# CITY OF ALBUQUERQUE

**Re:** Sigma Chi Parking Lot  
**1835 Lomas Blvd NE**  
**Traffic Circulation Layout**  
Engineer's Stamp dated 12-06-16 (J15D098)

Re: Sigma Chi Parking Lot  
1835 Lomas Blvd NE  
Traffic Circulation Layout  
Engineer's Stamp 08-02-16 (J15D098)

**RE: Sigma Chi Parking Lot  
Grading and Drainage Plan  
Engineer's Stamp Date – 8-2-2016  
Hydrology File: J15D098**

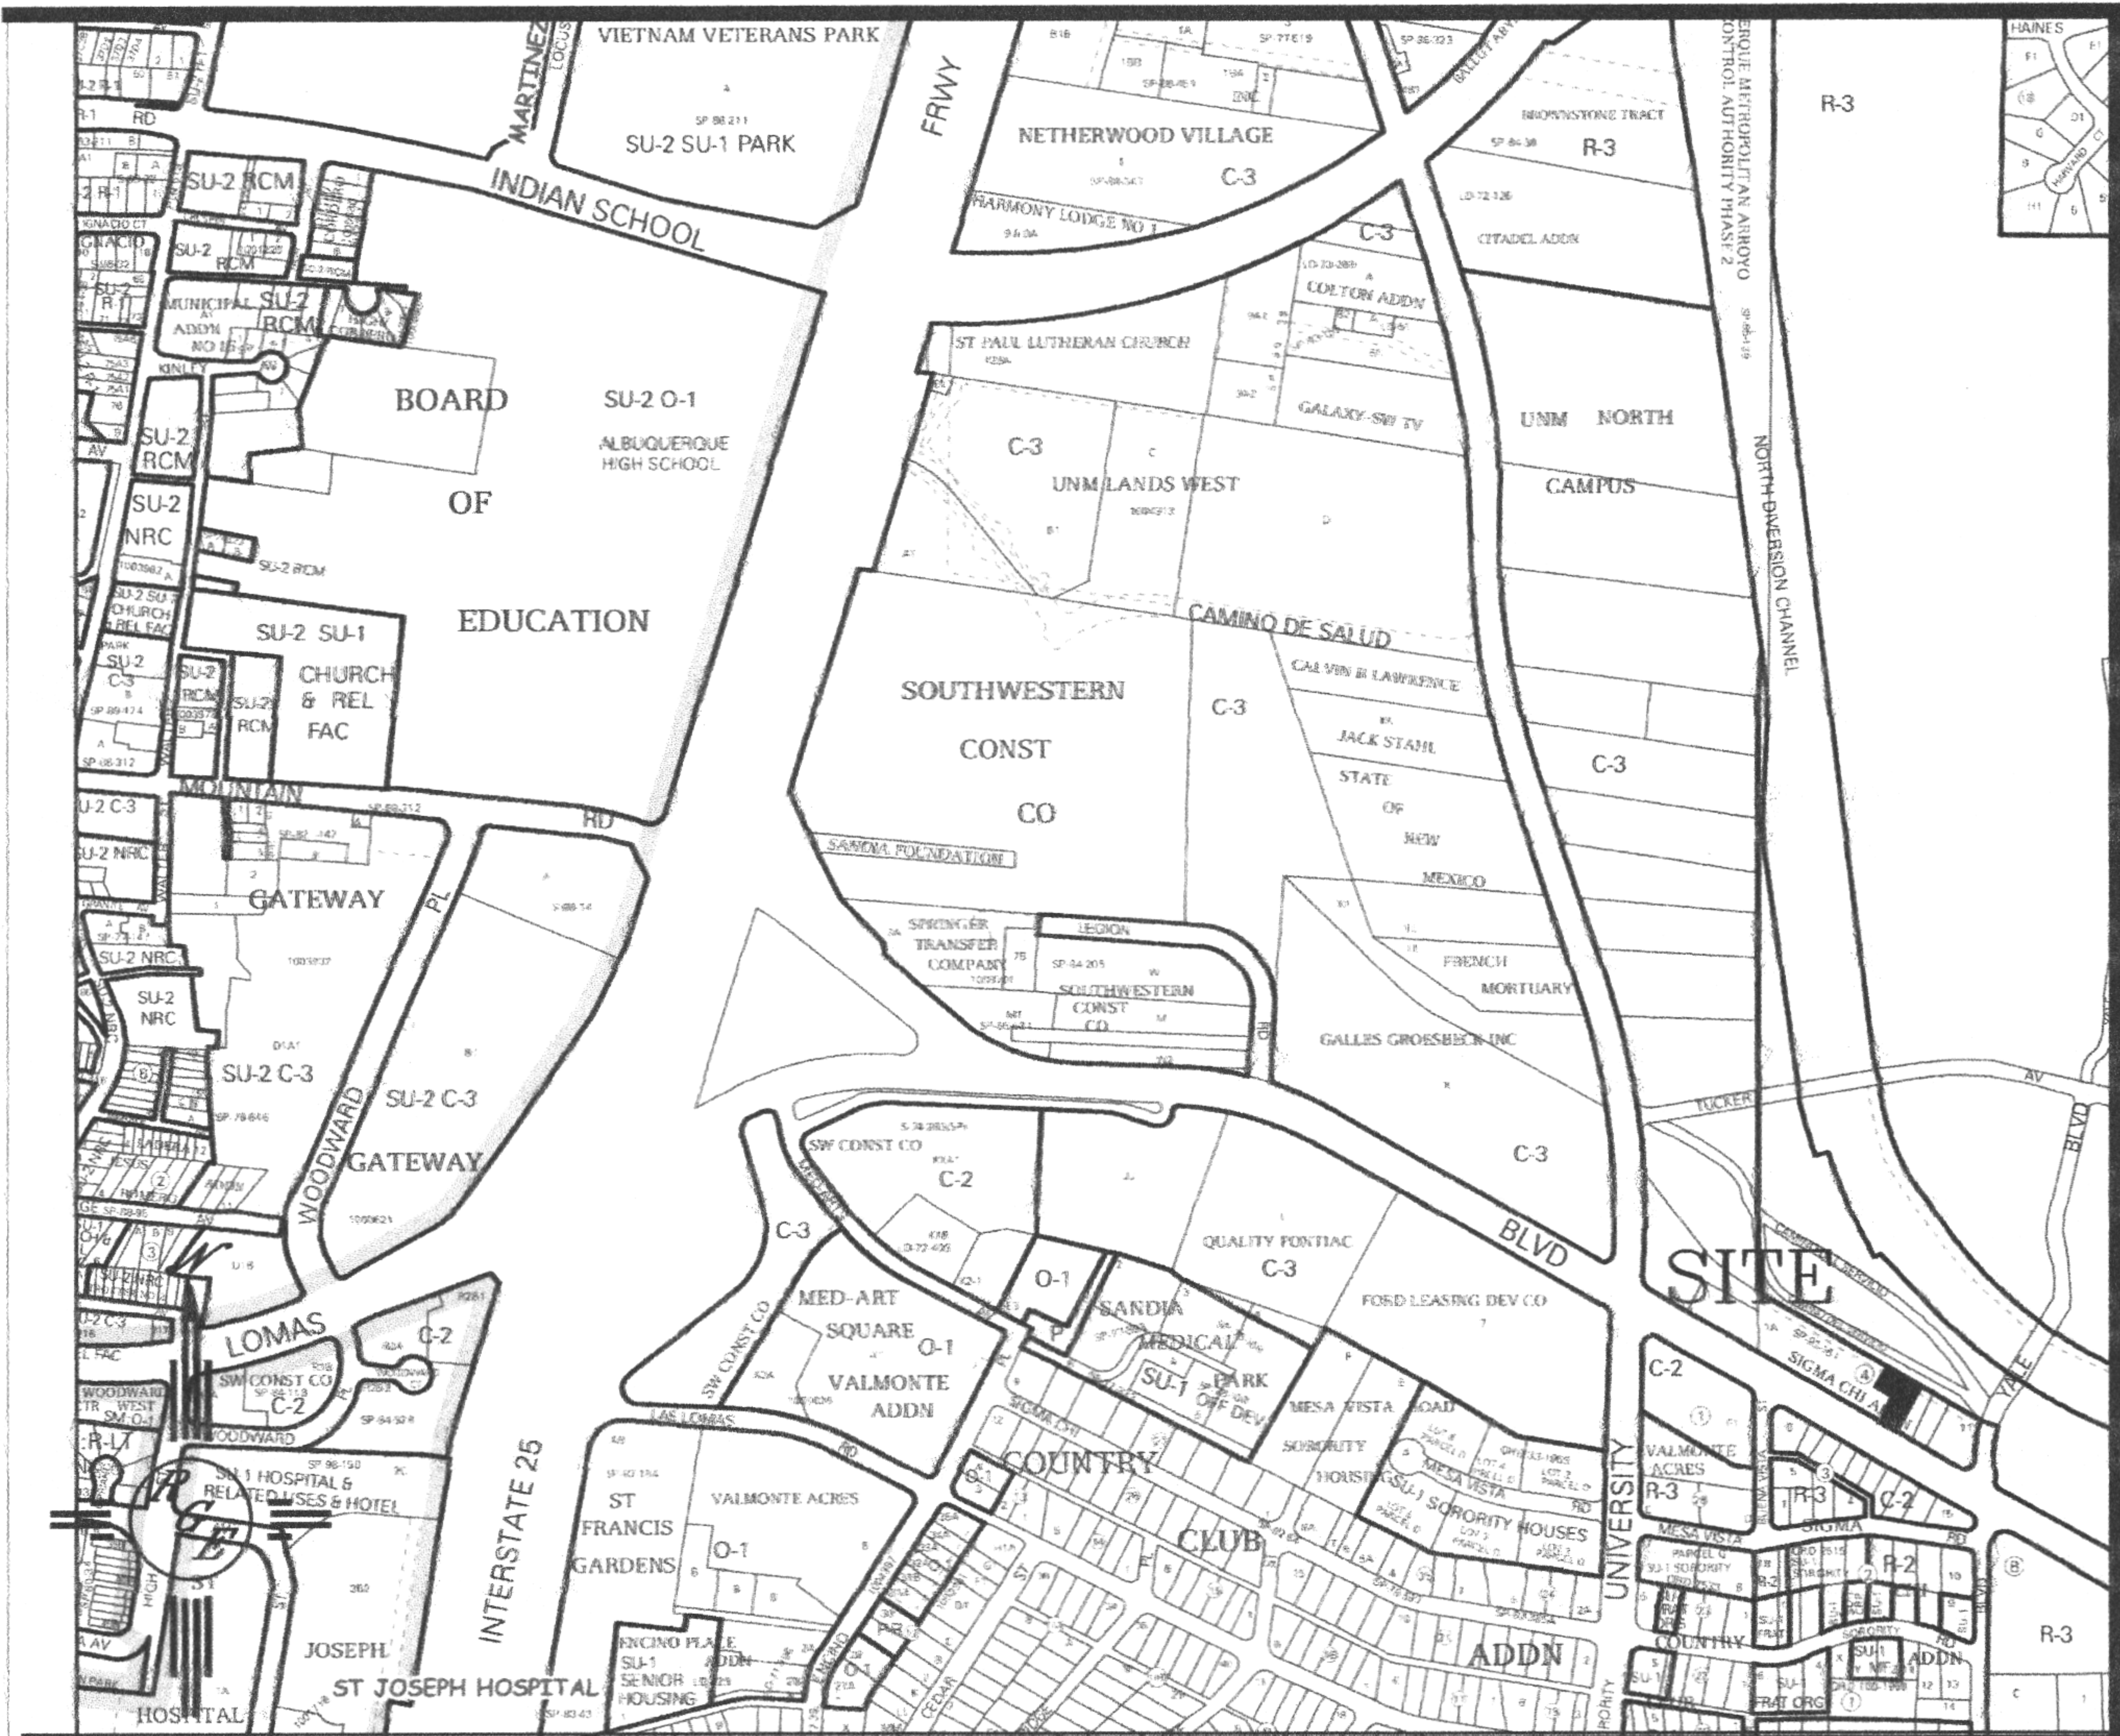
Is it required?!

Combine

20. See Chapter 23, Section 6 of the City of Albuquerque *Development Process Manual*, for appropriate drive pad widths. *Drawings.*
21. All broken or cracked sidewalk must be replaced with sidewalk and curb & gutter. A build note must be provided referring to the appropriate City Standard drawing. *Draw & meet ADA std.*
